File 1994-0035

Name: North Valley Subdivision – Final Plat/Plan

TITLE HEADING: Final Plat/Plan - North Valley
Subdivision

Re: **RESPONSE TO REVIEW COMMENTS**
NORTH VALLEY SUBDIVISION FILE #35-94(3)

COMPOSITE PLAN
 NORTH VALLEY SUBDIVISION

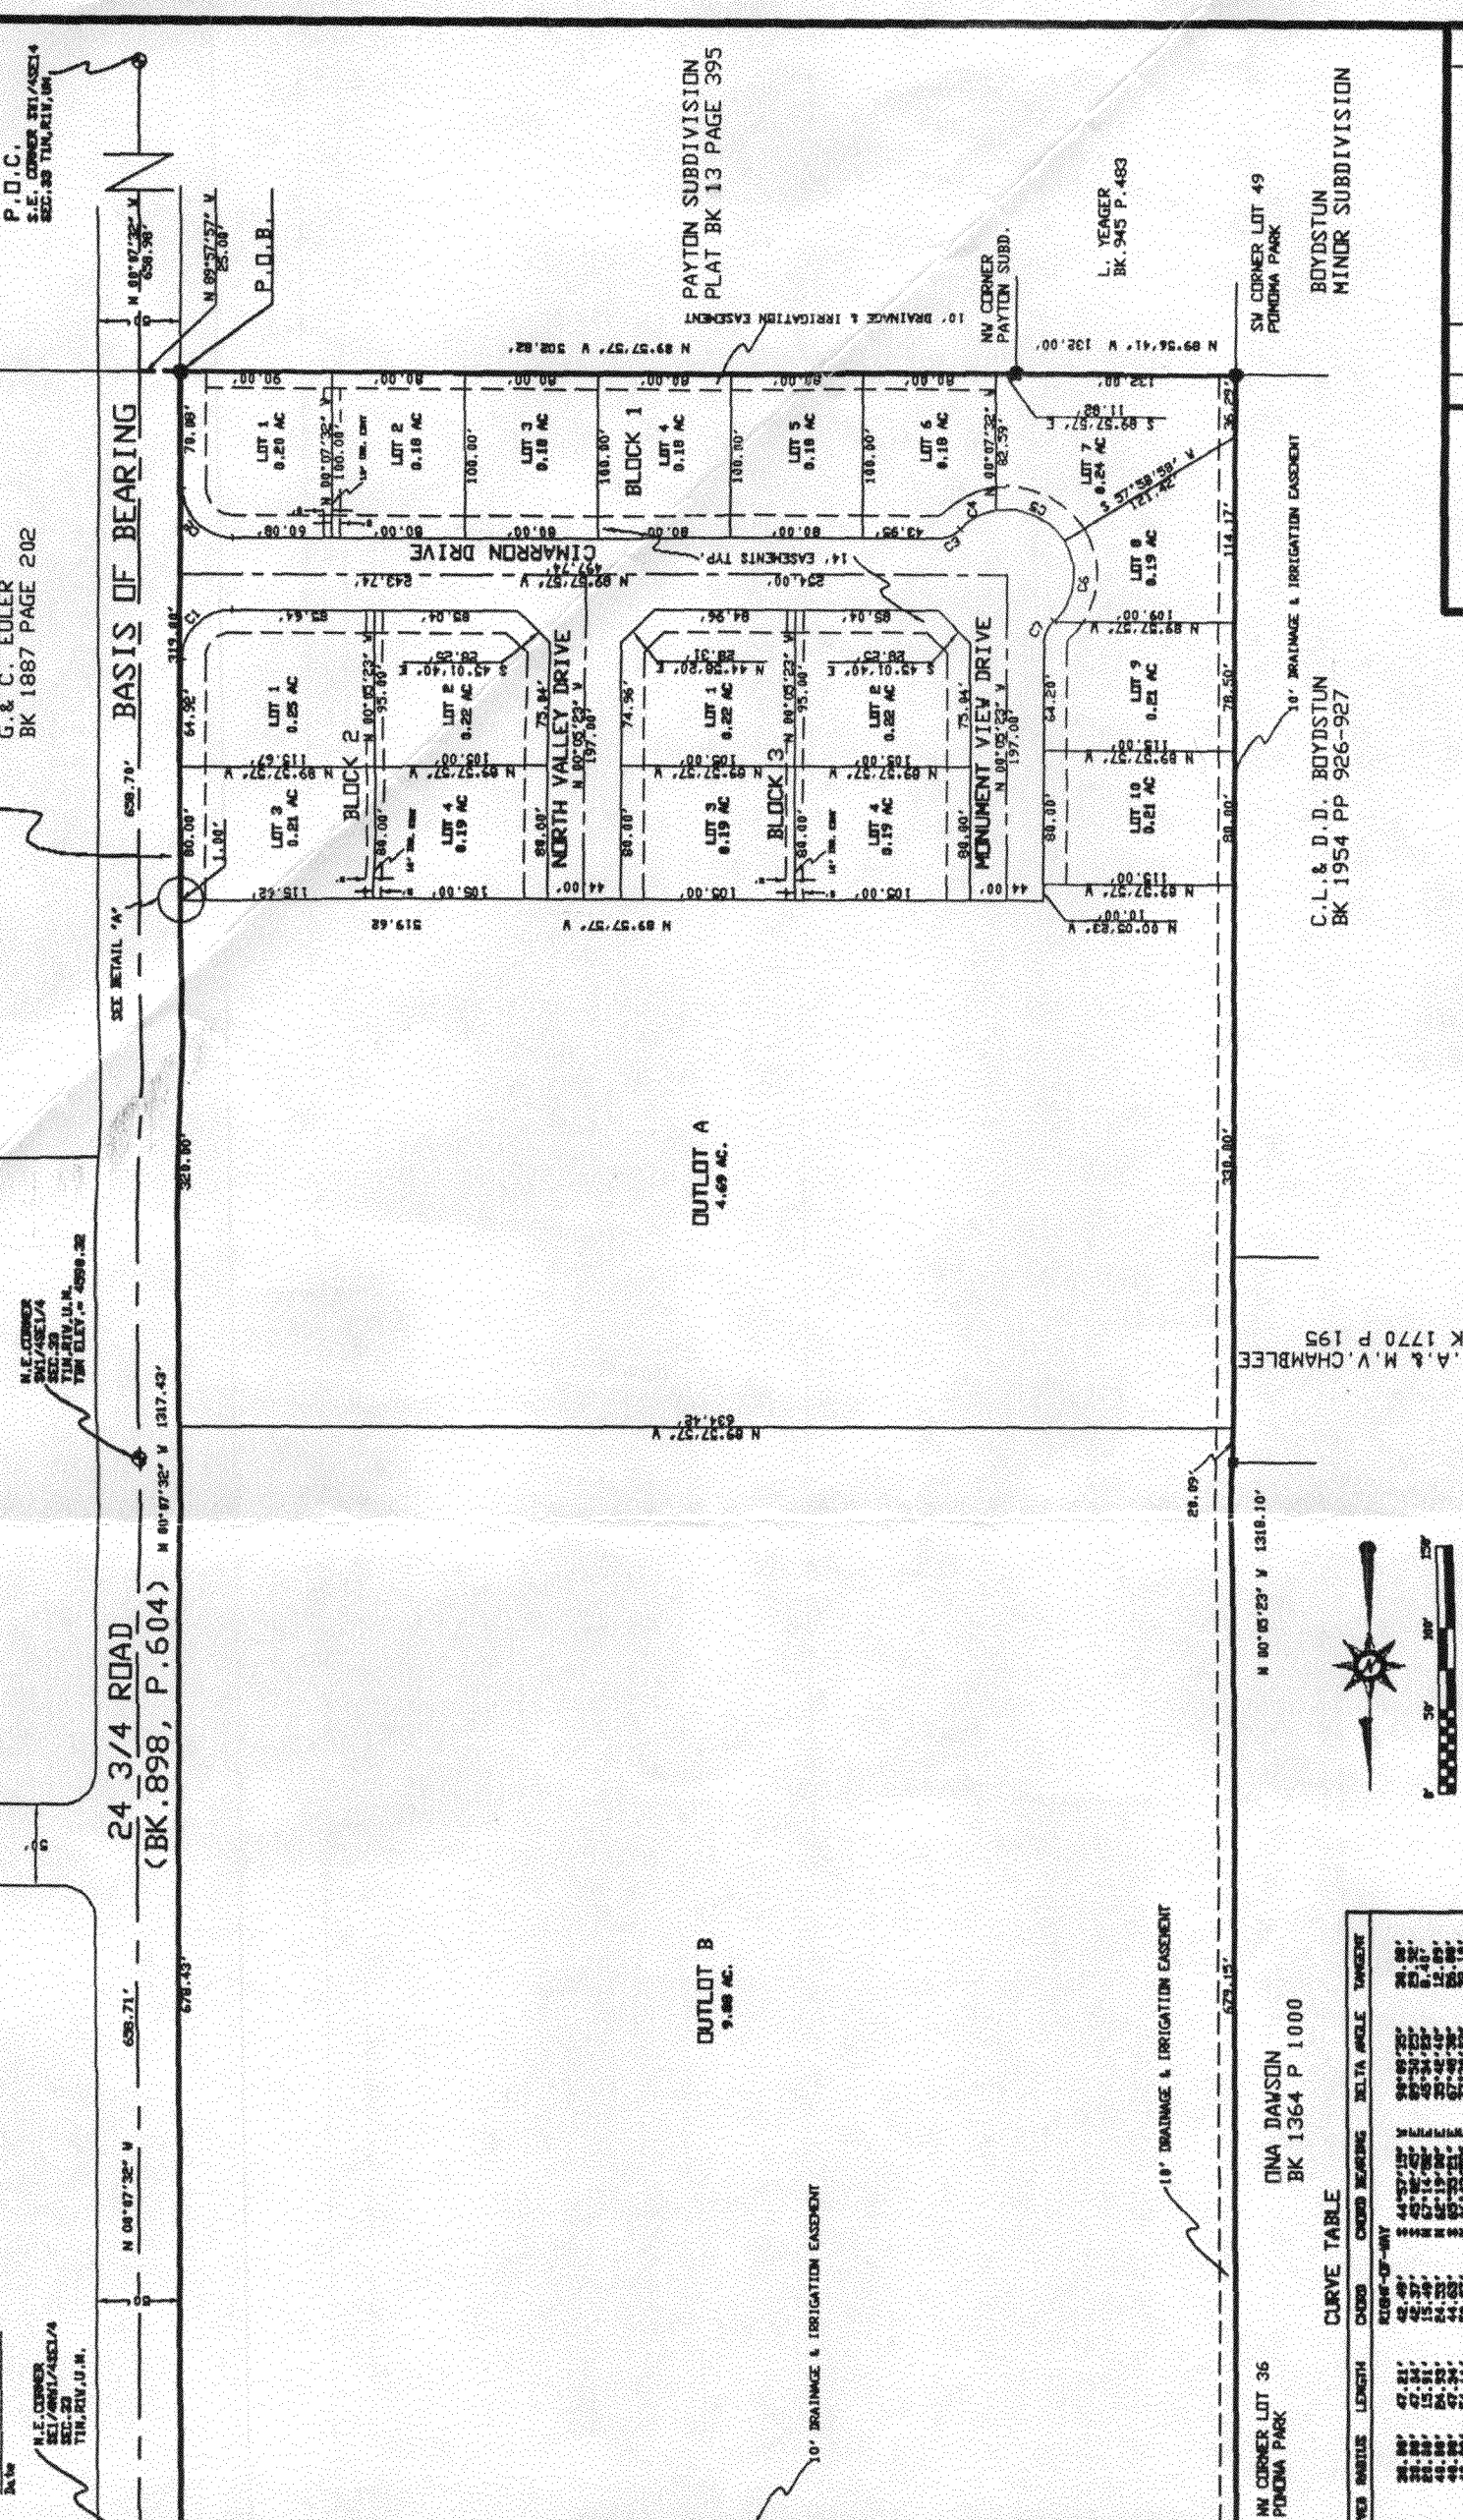
The fire hydrant at the northwest corner of Lot 12 of Block 2 needs to be moved to between Lots 6 & 8 of Block 2. An approved turnaround or access must be provided at the north end of Monument View Drive and North Valley Drive. Submit revised plans that reflect these changes for our review.

1. Please label the use (multi-purpose?) and provide appropriate dedication language for the 14' easements shown on both Filings.
2. The labeling for the 10' drainage and irrigation easement along the south line of Filing One appears to have been left dangling on the plat for Filing Two.
3. Should the lot numbering for Filing Two have some autonomy, rather than being carried over from Filing One?

- 1) 14' easements will be labeled multi-purpose and dedication language will be revised.
- 2) Labeling of 10' drainage and irrigation easement will be revised.
- 3) Lot numbering will be revised for Filing Two.
